RE: REVISED ENGINEER CERTIFICATION FOR GRACE PLACE SUBDIVISION  
(J17-D24) CERTIFICATION STATEMENT DATED 8/31/98 DRB96-092  
WO 5558.81 FINANCIAL GUARANTEE RELEASE

RE: ENGINEER CERTIFICATION FOR GRACE PLACE SUBDIVISION (J17-D24)  
CERTIFICATION STATEMENT DATED 6/22/98

RE: AMENDED GRADING & DRAINAGE PLAN FOR GRACE PLACE (J-17/D24)  
A.K.A. SUNNINGDALE LOT SPLIT  
RECEIVED OCTOBER 16, 1996 FOR FINAL PLAT  
ENGINEER'S STAMP DATED 10-9-96

RE: GRADING & DRAINAGE PLAN FOR GRACE PLACE (J-17/D24)  
A.K.A. SUNNINGDALE LOT SPLIT  
RECEIVED AUGUST 22, 1996 FOR PRELIMINARY & FINAL PLAT  
ENGINEER'S STAMP DATED 7-15-96

Cross Section  
Cross Section for Irregular Channel

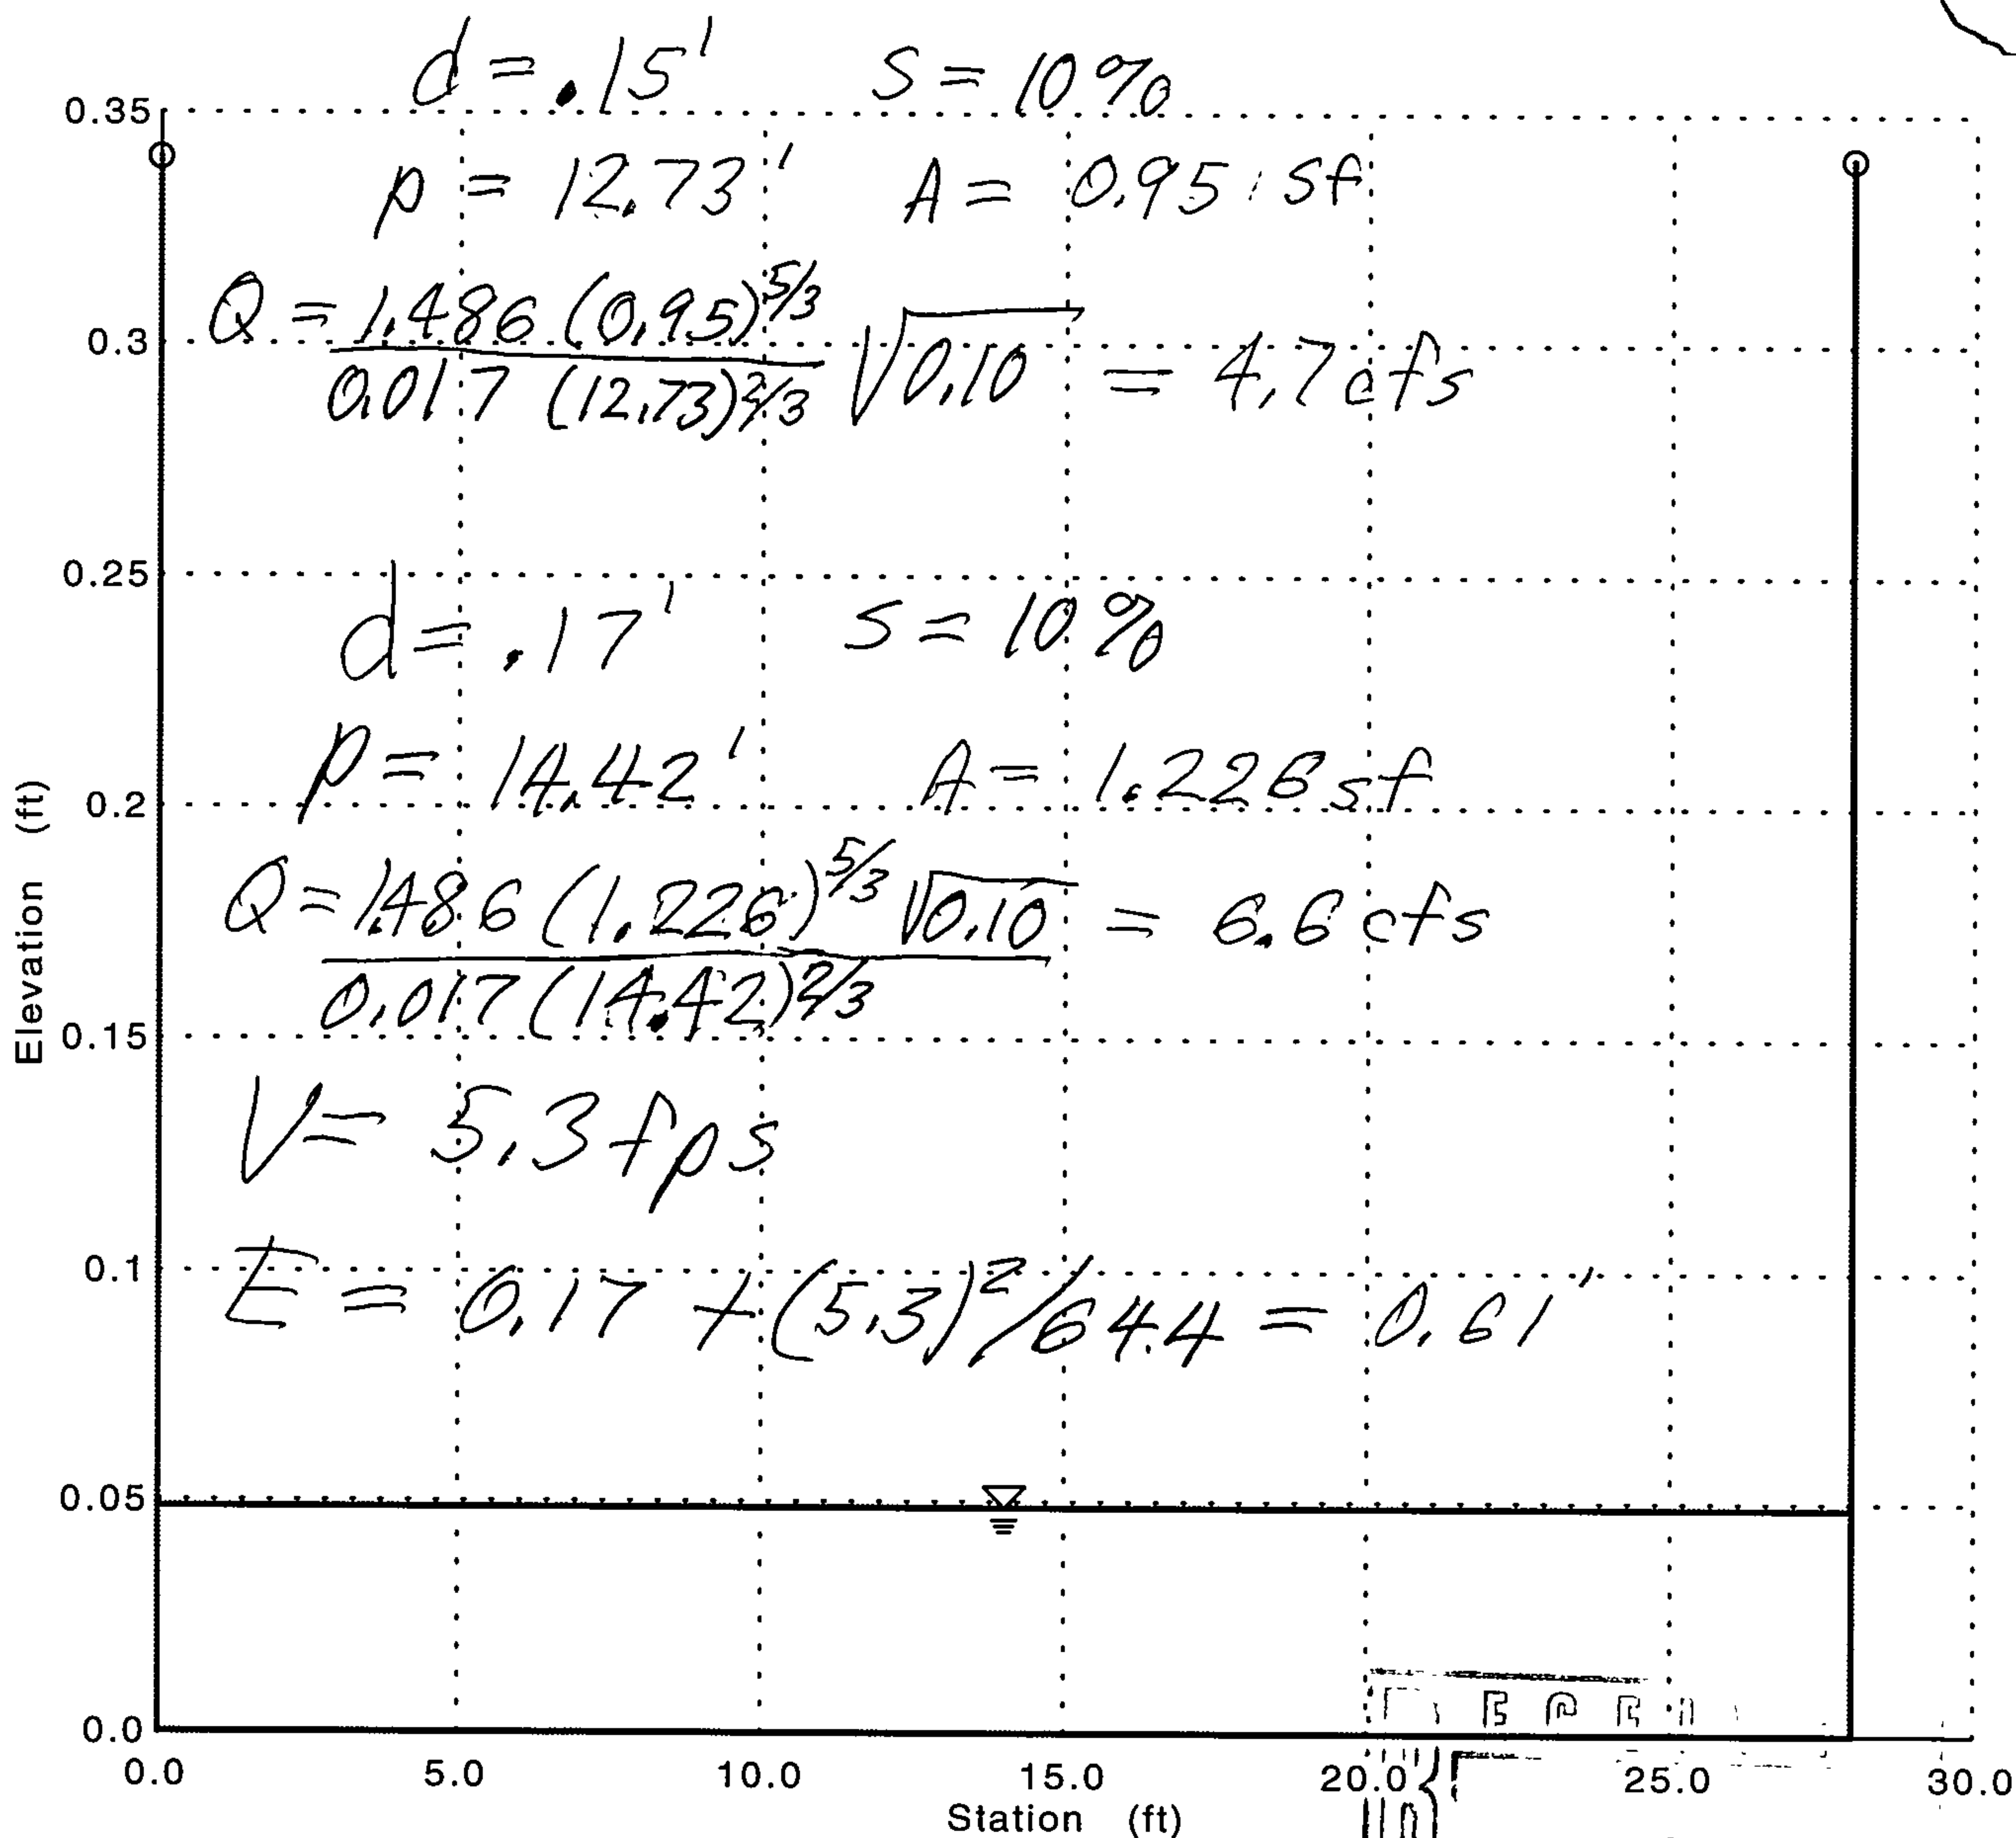
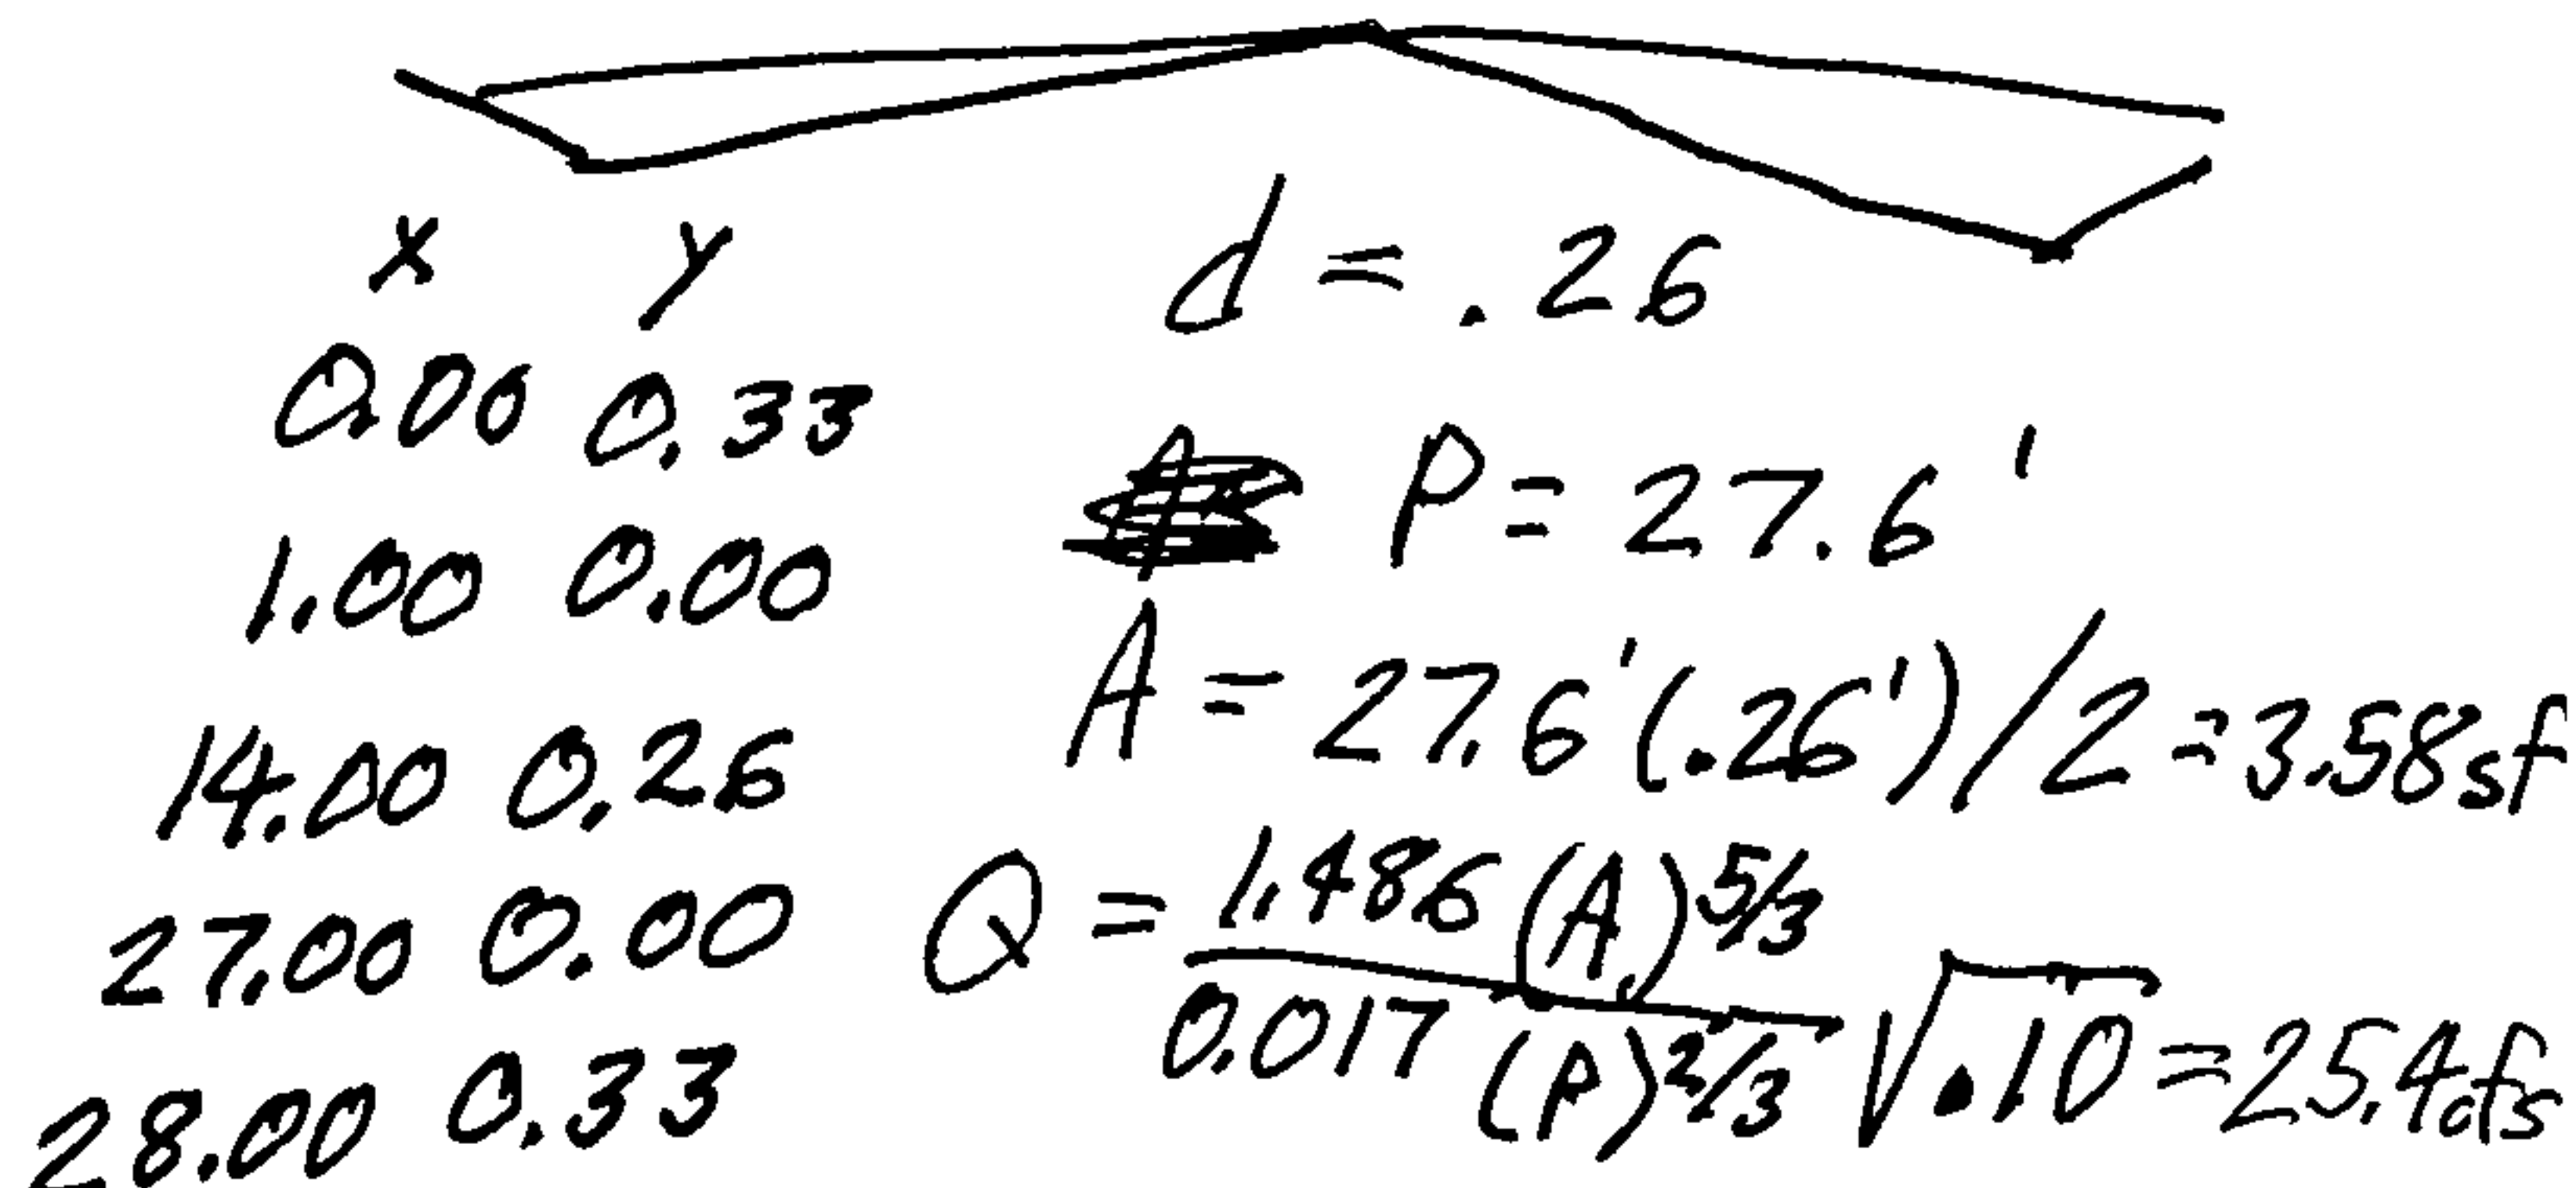
Engineer's Certification of grading & drainage per DPM checklist must be accepted by City Hydrology before the Financial Guaranty will be released. The channel hydraulics printout does not indicate the cross section analyzed nor does it indicate how the weighted "N" was calculated.

We have used mountable curb for Gracia Ct (see attached Channel hydraulics) and a valley gutter has been added.

STREET CAPACITY

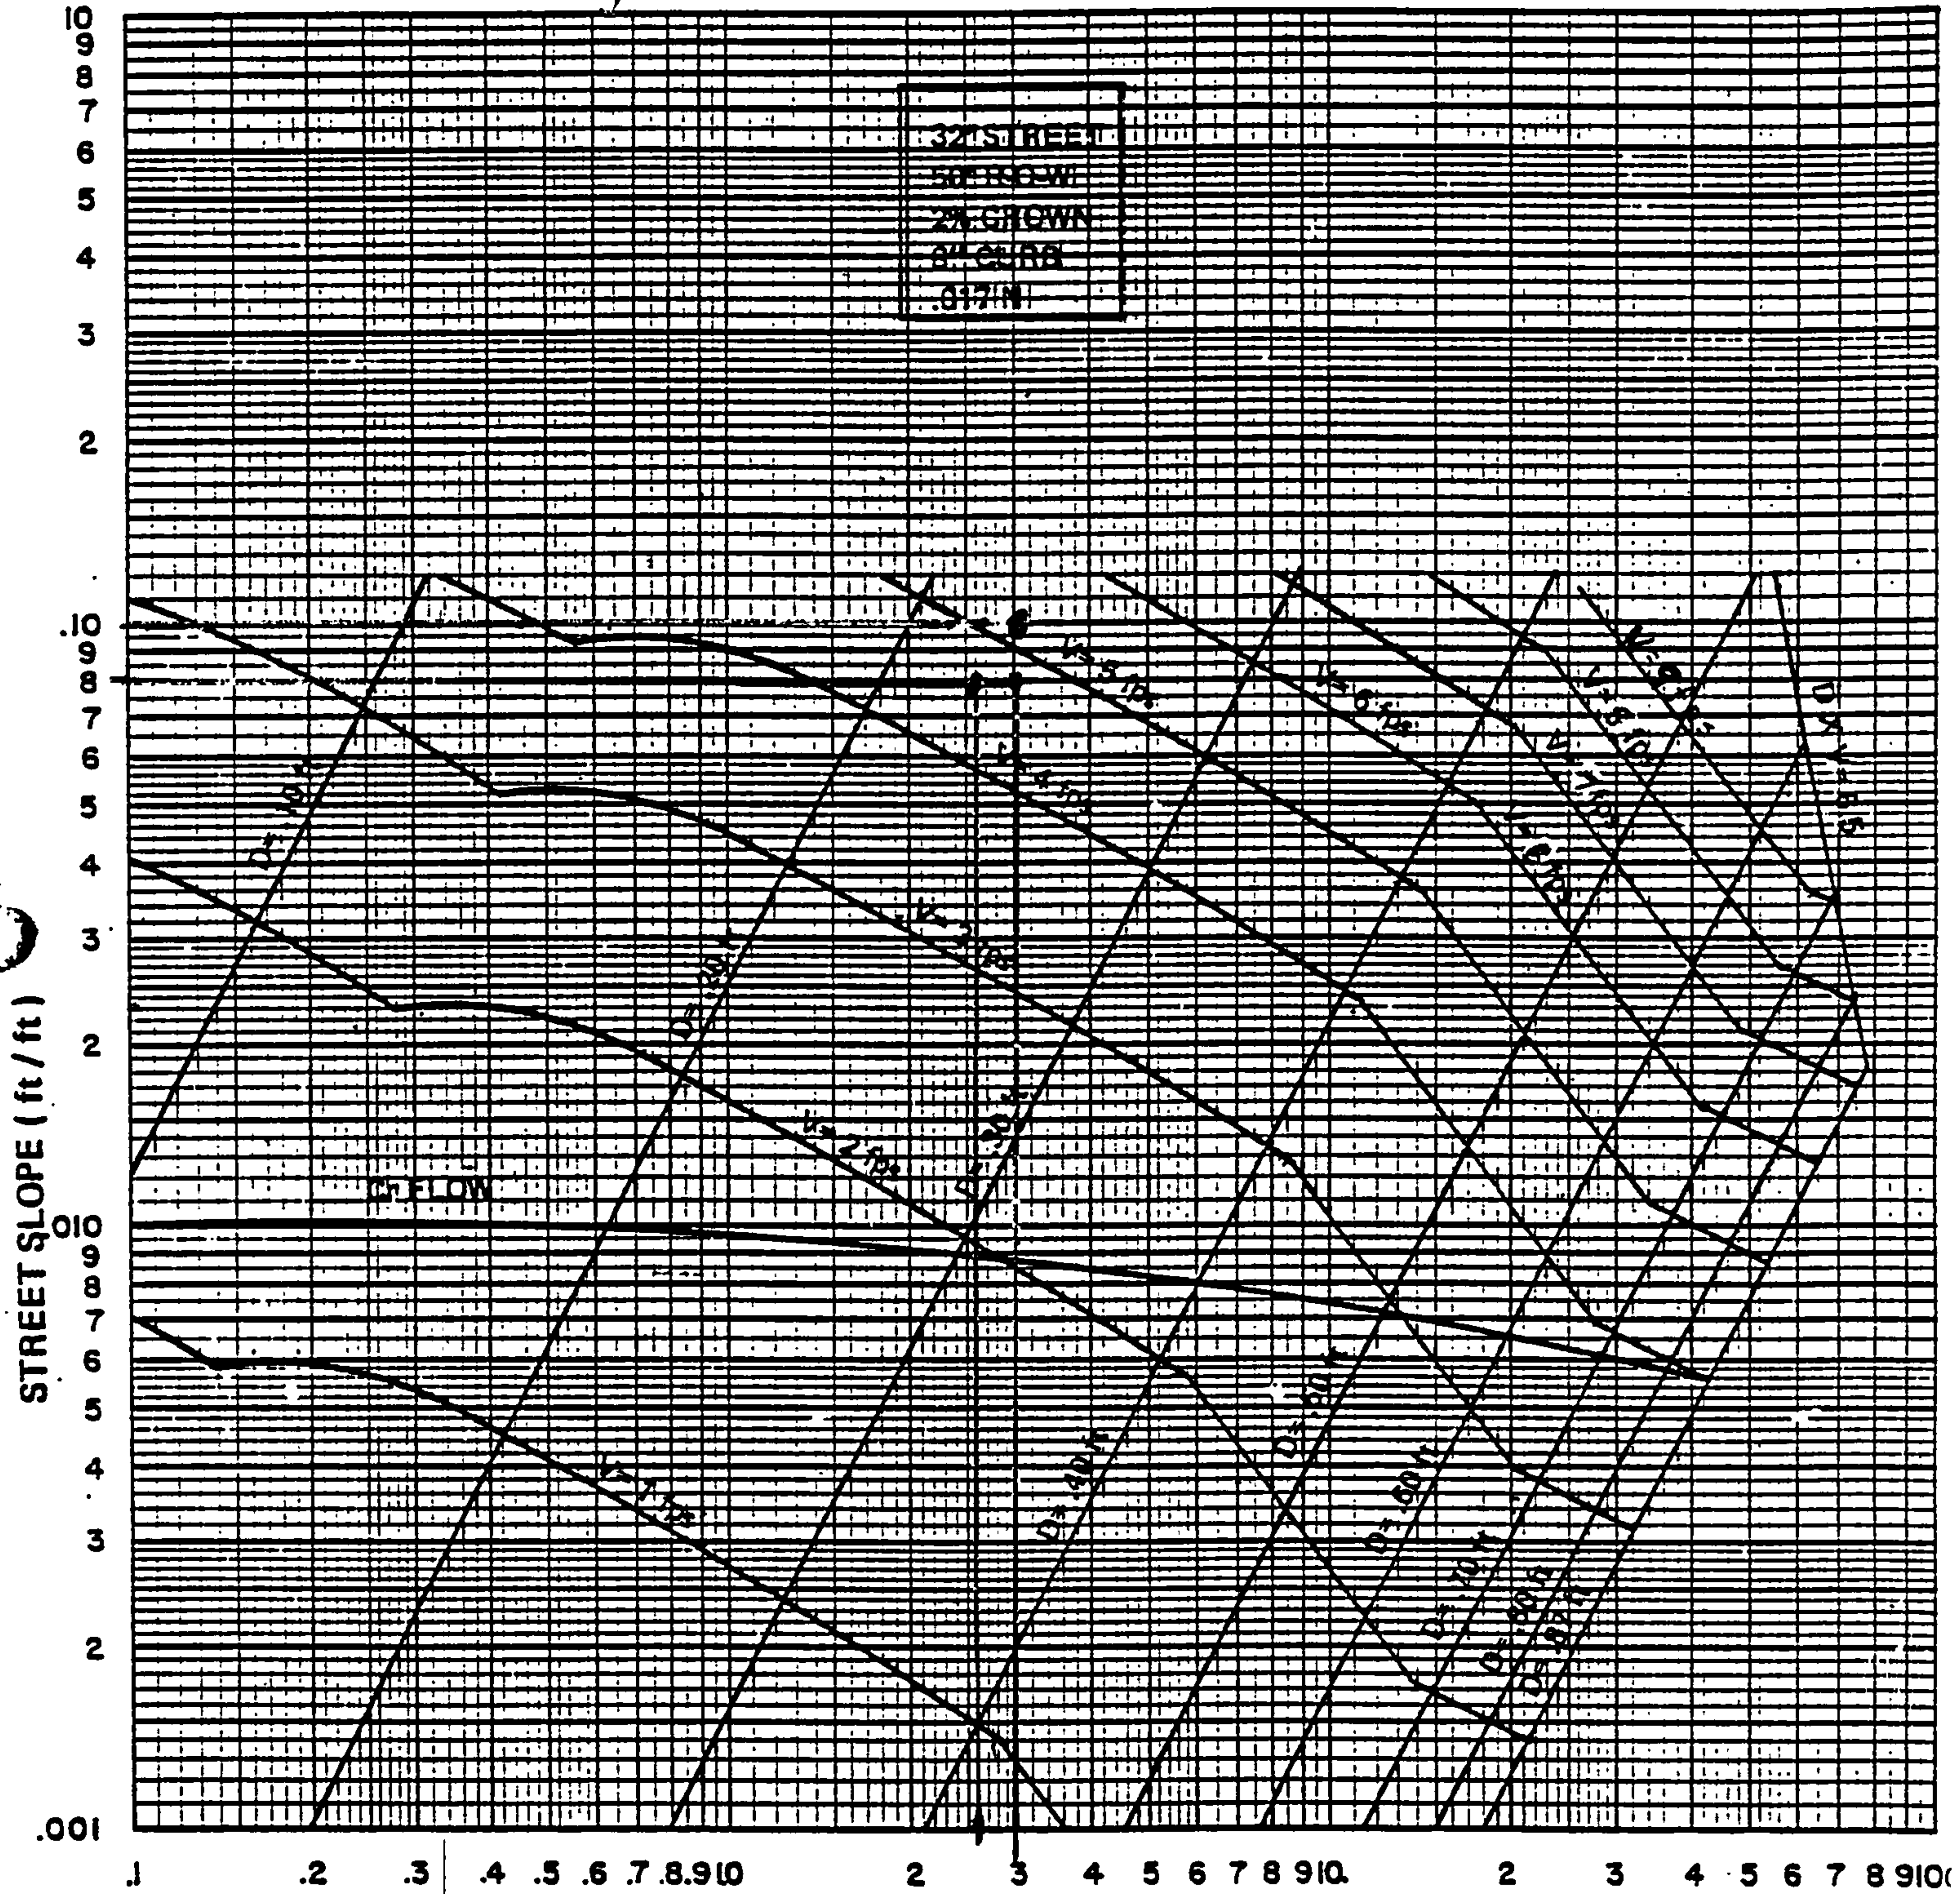
Velocities > 6 fps were labeled wrong JPC 4/21/9. 22.3
